STATE OF NORTH CAROLINA
DEPARTMENT OF TRANSPORTATION

Subject: **1) Section 404 Nationwide Permit 3/33 & 401 Individual Water Quality Certification** for the “Upper Section” of NC 9 (from “Station 37” to the Buncombe County Line).
2) Modification to Site 1 of the previously issued permits for the “Lower Section” (NC 9 from US 74A to Station 37).
3) Additional Information pursuant to questions from the September 5, 2025 project “walk-thru”
Henderson County, Division 14, WBS 18314.1045061.

Reference: 404 Permit; Action ID: SAW-2025-00325, dated 8/8/2025.
401 Certification; Project No. 20250664, dated 8/4/2025.

The North Carolina Department of Transportation (NCDOT) provides the following supplemental information, provided to answer question and provide additional information after the September 5, 2025 “virtual walk-thru” for the above referenced project.

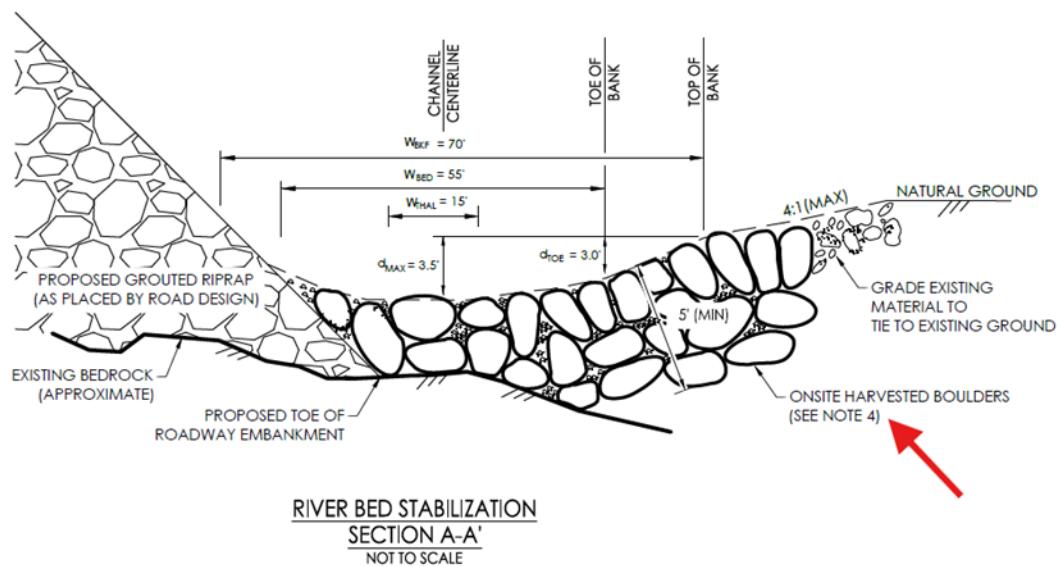
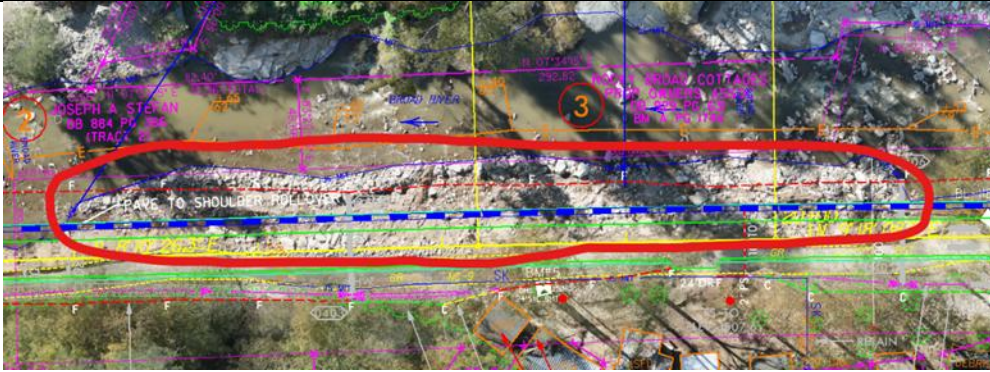
David McHenry (NC WRC): The application mentions the river bed is bedrock, but it also notes; All river material will consist of previously harvested river material which was deposited in upland areas and temporarily used to re-stabilize NC 9, on Sheet 4. Specifically, where is that material coming from? Is it the excavated road bed material in the attached picture (left side) where the single lane NC 9 has been (may still be)? I haven't been down there in a while so I'm not sure what other changes may have occurred down there in last 2-3 months.

Response: Here's an excerpt of the attached in-stream construction detail. Boulders will be harvested on-site along the river including using what's remaining of the temporary berm that was built right after the storm that allowed them to build the temporary gravel "road" right after the storm. Coincidentally, the stream morphologists recommended that these boulders be removed because they were causing a high energy concentration that wasn't present in the river pre-Helene so they will be beneficially used to stabilize the river.

Boulders outlined in red below will be used in Site 1.

Note 4 will allow the contractor to use non-native boulders in the lower layer topped with the harvested layer if there are not enough harvested boulders.

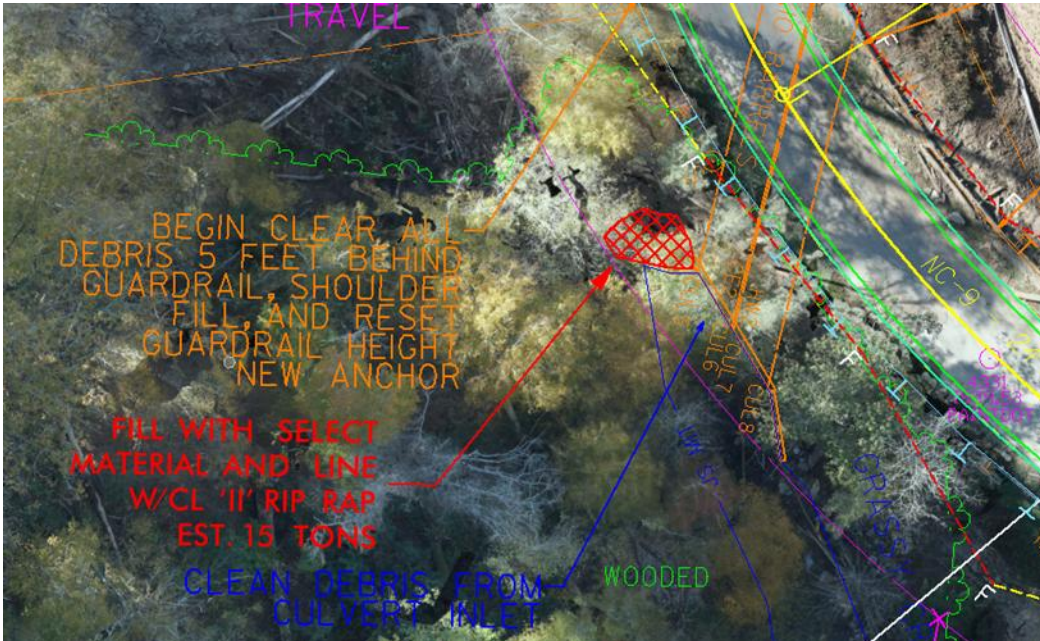
David McHenry (NC WRC): Also, at site 7, is that short class II section the fill planned to fix to the RCBC perch (and stabilize the right bank)? Attached is a picture of this area.

Response: At the Inlet, we proposed to place Class II Rip Rap behind the wingwall to repair some Helene erosion.

At the Outlet, we propose to place Class II Rip Rap in the creek to repair the perched culvert. As requested in the meeting, we have prepared a detail that will direct the contractor to channelize this rip rap.

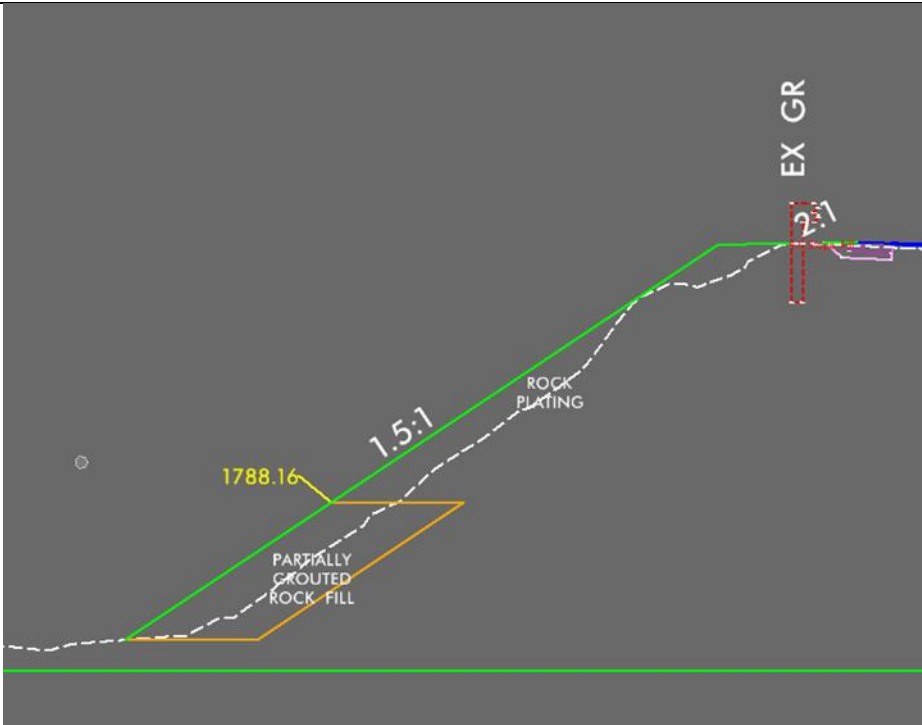
David McHenry (NC WRC): And, what is the stabilization material and the profile (x-secs available?) proposed to extend 400 feet or so downstream? I didn't see (but may have missed) a description/detail.

Response: Downstream from the outlet will be repaired using the same method we used along the Broad River. The stabilization material will be grouted Class VII rip rap at the toe of the slope and Class II rip rap on up the slope where it is Rock Plating as detailed in the Geotechnical portion of the plans. See below for a typical cross section at station 62+50.

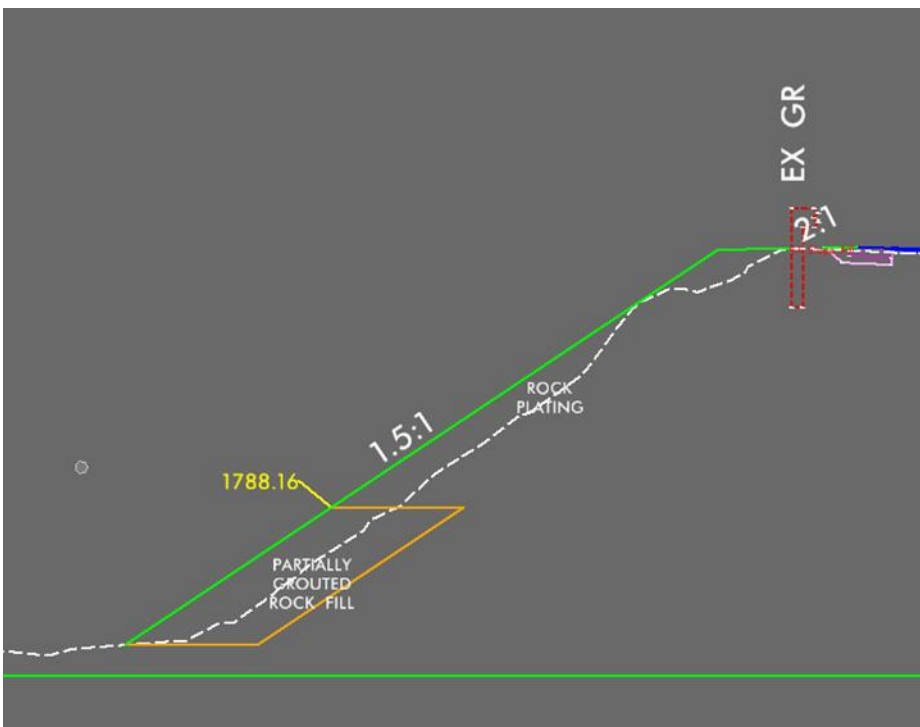
David McHenry (NC WRC): Anyway, if they go with another grouted embankment here, they should replace those very abundant boulders that are in the active channel (see photos) to retain some existing habitat complexity, like the approach recommended at site 1. I'd hate to see that converted to ditch-like cross-section.

Response: As shown in the cross section at Station 62+00 below, it is not NCDOT's intention to disturb the boulders that are in the stream bed of Grassy Creek shown in your photos, only stabilize the roadside fill slope and not go beyond the pre-Helene edge of creek. From your pictures, we believe grass has grown from the hydroseeding and that grass is hiding some of the damage that needs to be repaired underneath. See photos below. The roadway and geotechnical engineers believe that these unstable areas need to be protected with rip rap.
